STAGE 4

project title	
KOKO + Hope & Anchor + Bayham Place Camden, London	
drawing title	scale date
Proposed Section DD	1:100 18.05.17
drawing number	drawn checked
AHA/KKC / PR /303	FR/PC DA
	revision
	C

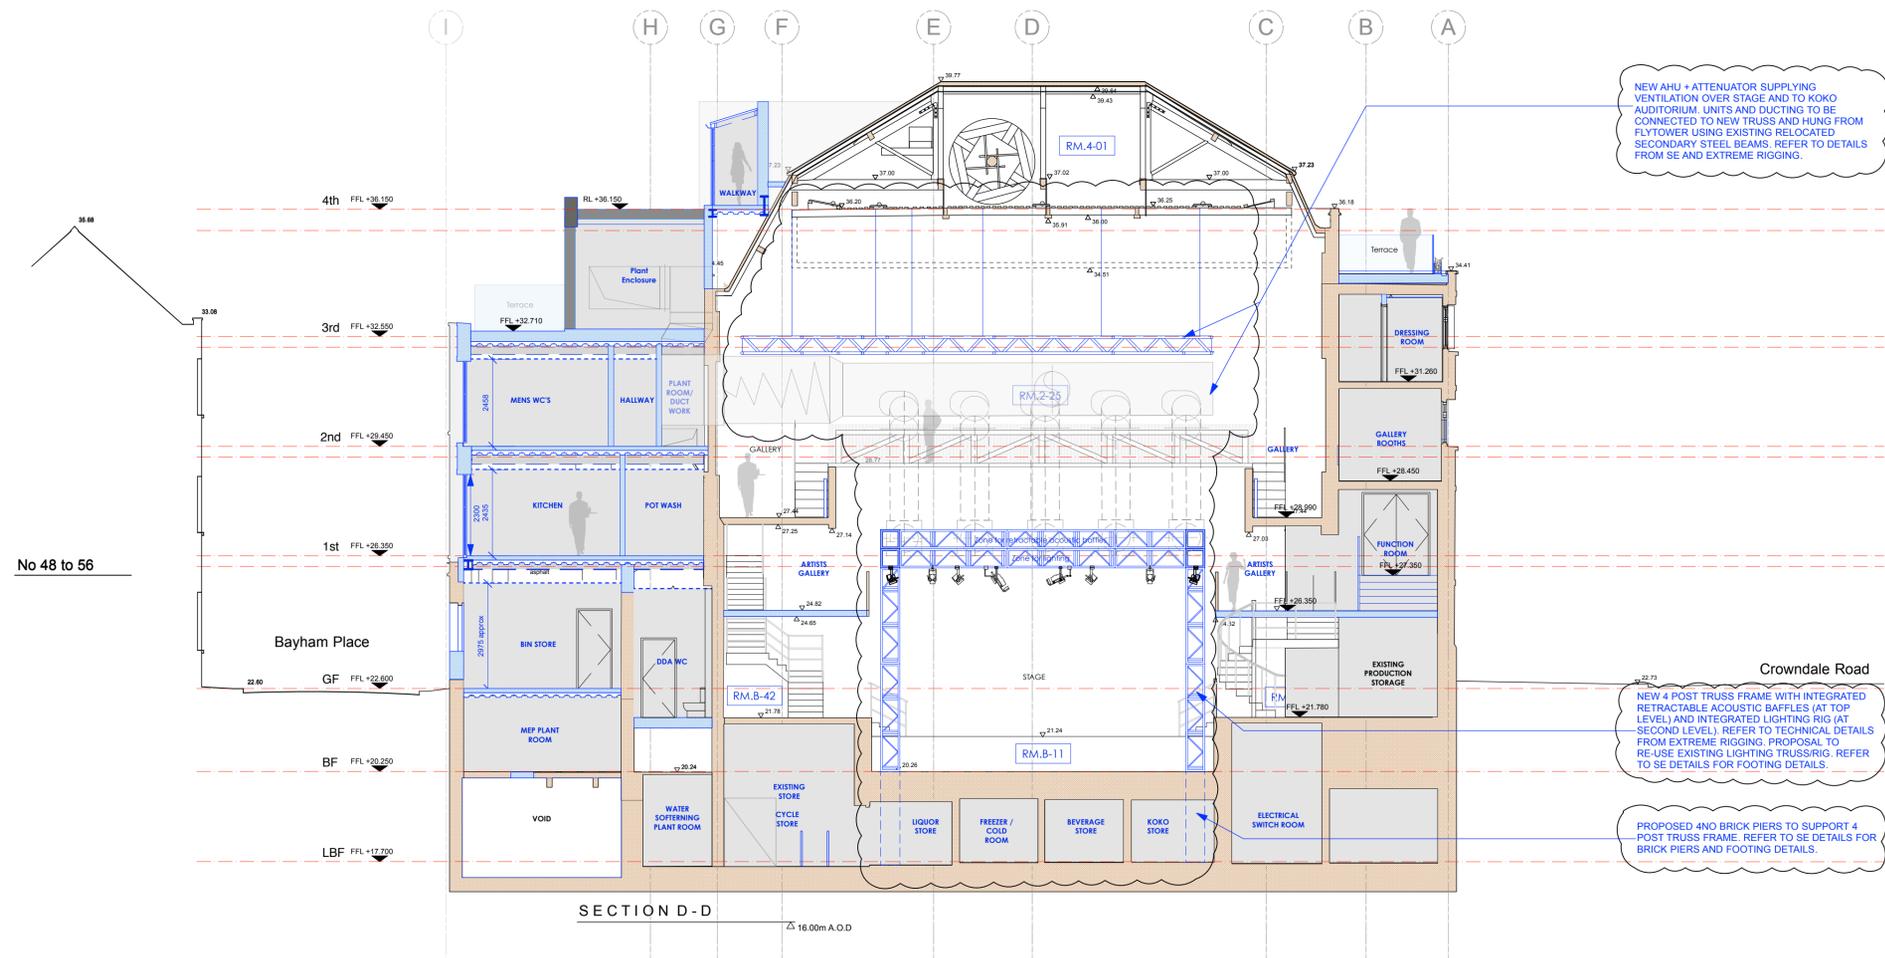
revision / date / amendments	
- / 26/01/18 /	- First Issue
A / 02/03/18 /	1. AHU + Attenuator for KOKO stage and auditorium shown indicatively.
B / 23/03/18 /	2. Indicative rigging/ space frame shown 1. Tender Addendum (1). Indication of 4 post truss fixed at stage level for integrated automatic retractable acoustic baffles and integrated lighting rig. 2. Tender Addendum (2). New AHU + Attenuator over stage to be hung to existing relocated secondary beams in Flytower.
C / 01/06/18 /	Listed Building Application 1. Indication of 4 post truss fixed at stage level for integrated automatic retractable acoustic baffles and integrated lighting rig. 2. New AHU + Attenuator over stage to be hung to existing relocated secondary beams in Flytower.

NEW AHU + ATTENUATOR SUPPLYING VENTILATION OVER STAGE AND TO KOKO AUDITORIUM. UNITS AND DUCTING TO BE CONNECTED TO NEW TRUSS AND HUNG FROM FLYTOWER USING EXISTING RELOCATED SECONDARY STEEL BEAMS. REFER TO DETAILS FROM SE AND EXTREME RIGGING.

NEW 4 POST TRUSS FRAME WITH INTEGRATED RETRACTABLE ACOUSTIC BAFFLES (AT TOP LEVEL) AND INTEGRATED LIGHTING RIG (AT SECOND LEVEL). REFER TO TECHNICAL DETAILS FROM EXTREME RIGGING. PROPOSAL TO RE-USE EXISTING LIGHTING TRUSS/RIG. REFER TO SE DETAILS FOR FOOTING DETAILS.

PROPOSED 4NO BRICK PIERS TO SUPPORT 4 POST TRUSS FRAME. REFER TO SE DETAILS FOR BRICK PIERS AND FOOTING DETAILS.
